ADDENDUM NO.: 01

ISSUED: June 24, 2024
to the Project Manual and Drawings for

CARTI El Dorado Cancer Center Phase 2
El Dorado, Arkansas
PSW Project No. 67IAG

-
- A. **GENERAL INFORMATION:** Addendum 01 contains revisions to Architectural drawings and MEP Specification Language as well a summary of Bidding question responses.

1 | PH2 ENLARGED PLAN - LINAC
1/4" = 1'-0"

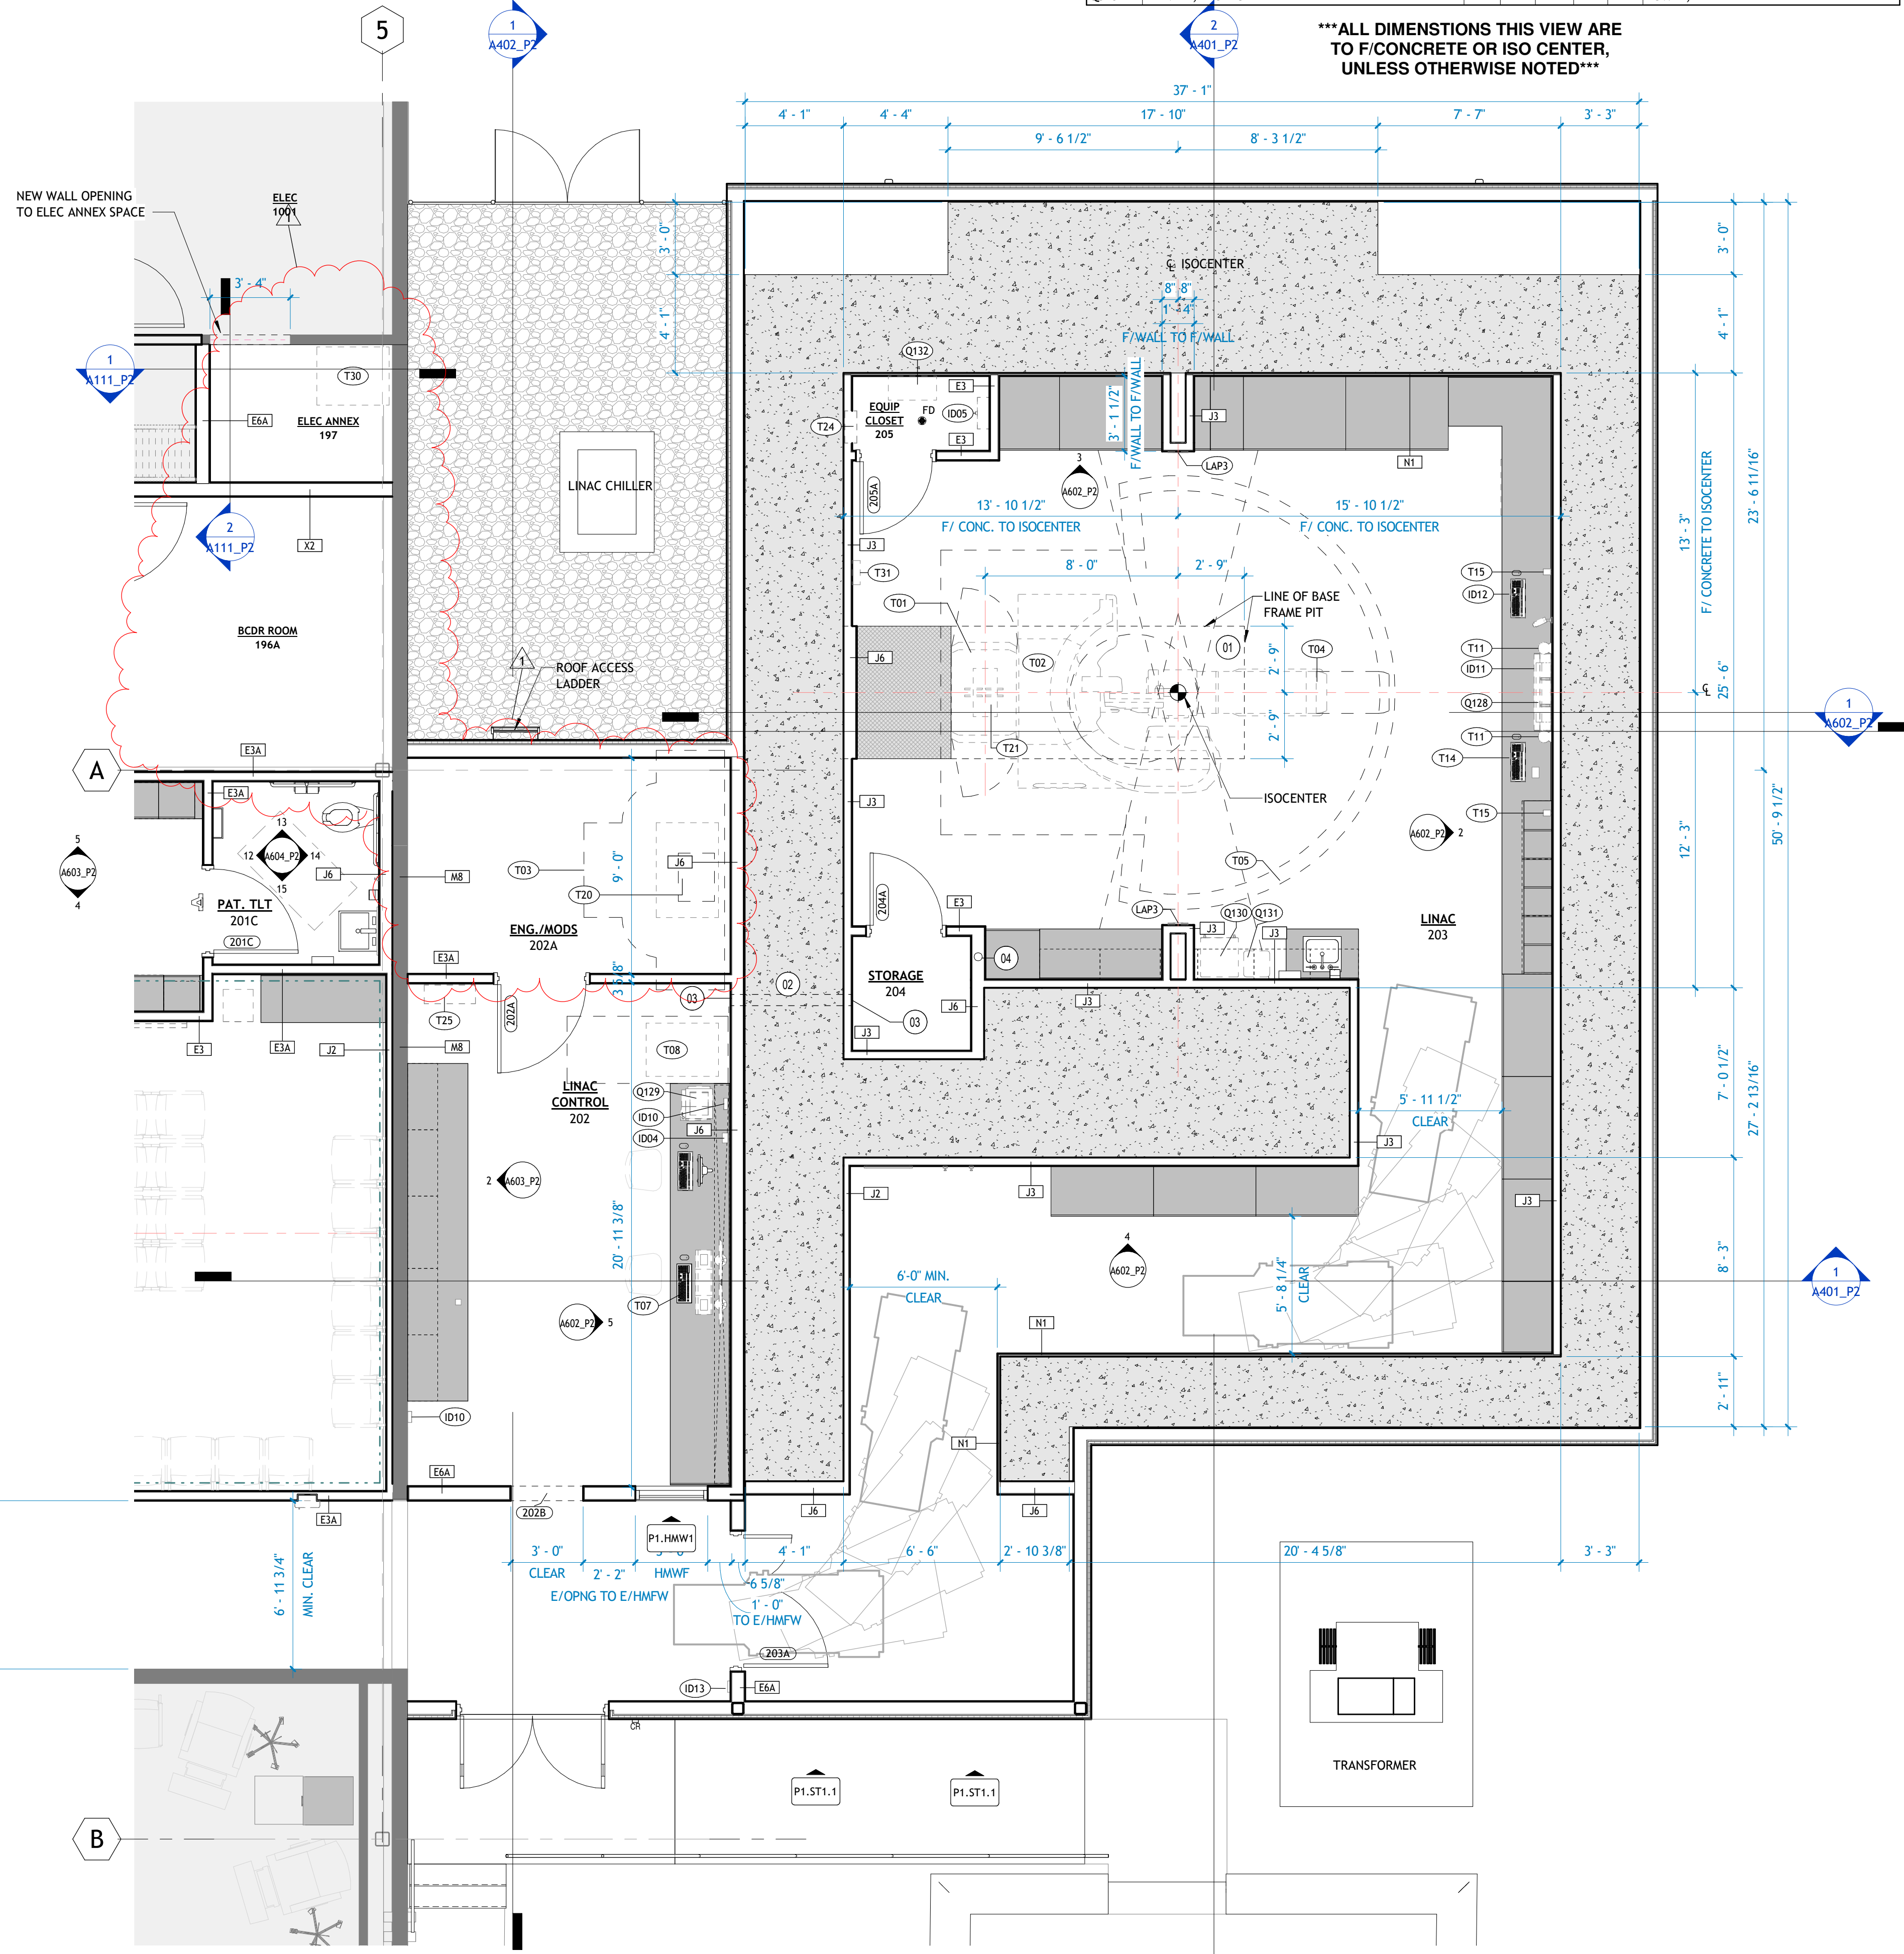
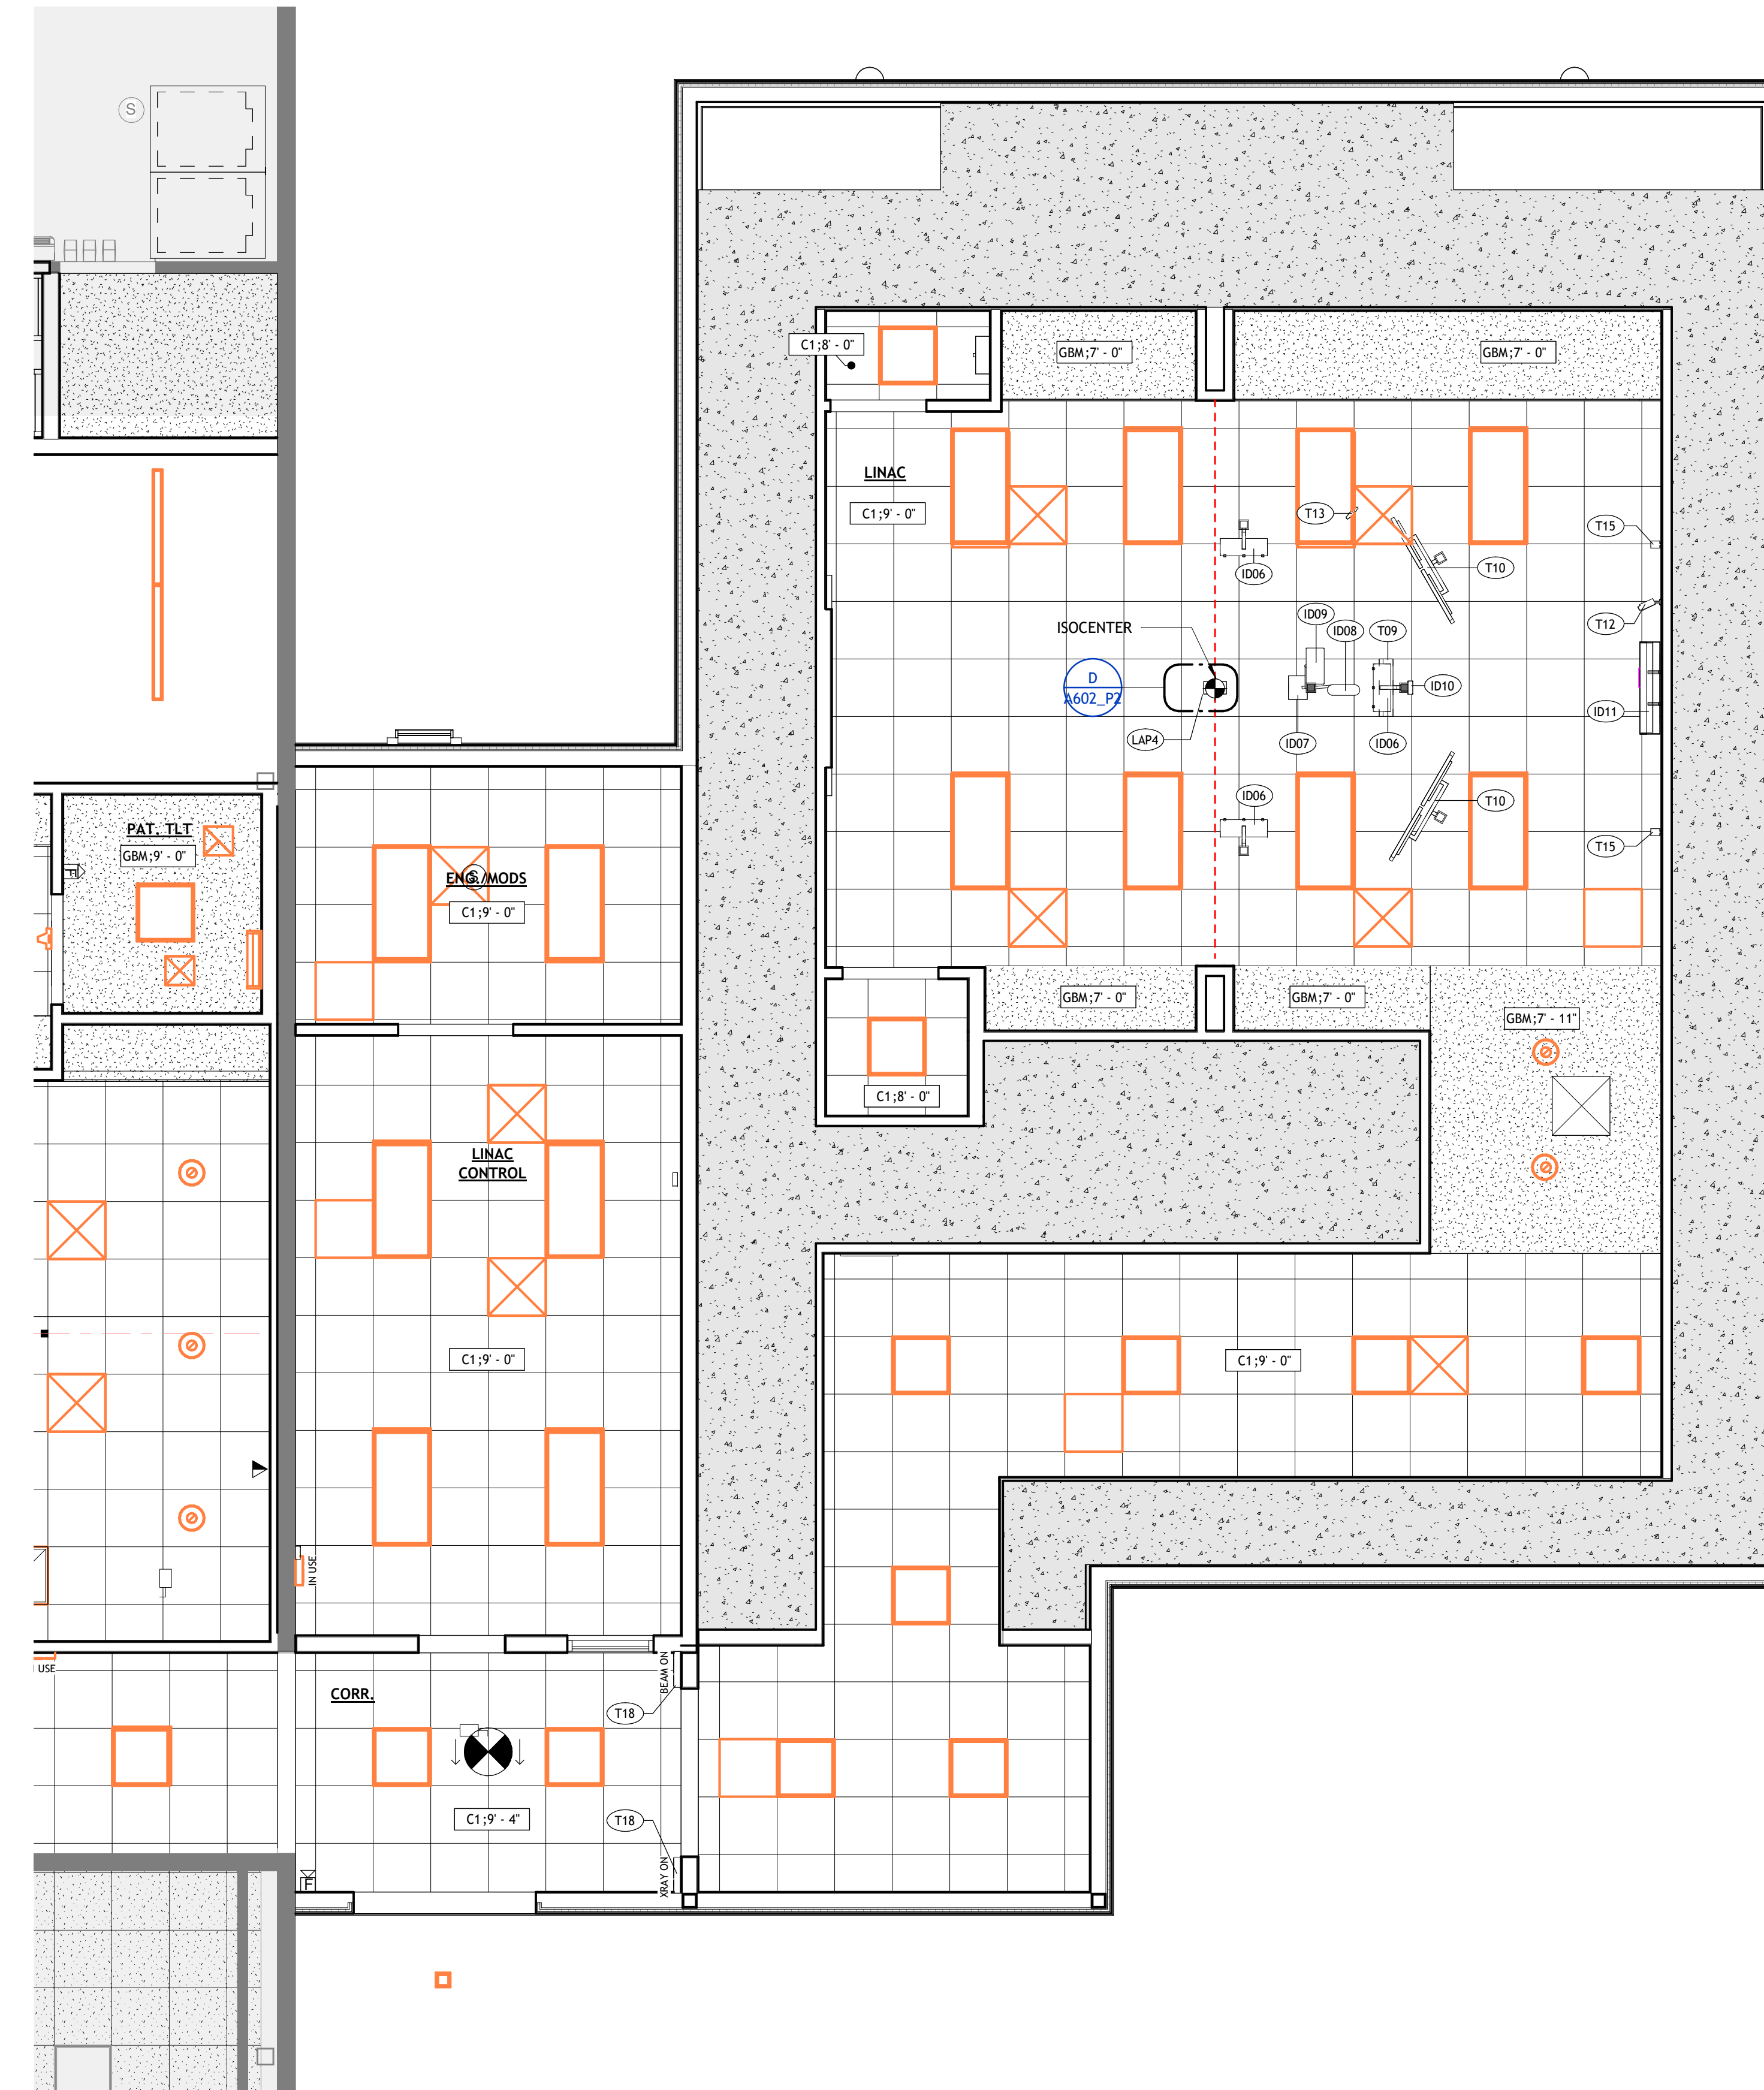
5. Refer to Revised Sheet **A601_P2– PH2_ENLARGED PLAN, RCP, EQUIPMENT LEGEND AND NOTES–LINAC**, revision dated 6.24.2024:
 - a. Revised Detail 1.
6. Refer to Revised Sheet **A602_P2– PH2_INTERIOR ELEVATIONS AND DETAILS**, revision dated 6.24.2024:
 - a. Revised detail 6.
7. Refer to Revised Sheet **A603_P2– PH2_ENLARGED PLAN & INTERIOR ELEVATIONS**, revision dated 6.24.2024:
 - a. Revised details 1.
8. Refer to Revised Sheet **A710_P2– PH2_DOOR AND WINDOW SCHEDULE**, revision dated 6.24.2024:
 - a. Revised Door Schedule.
9. Refer to Revised Sheet **A801_P2– PH2_FINISH PLAN**, revision dated 6.24.2024:
 - a. Revised BCDR Plan location and schedule revision.
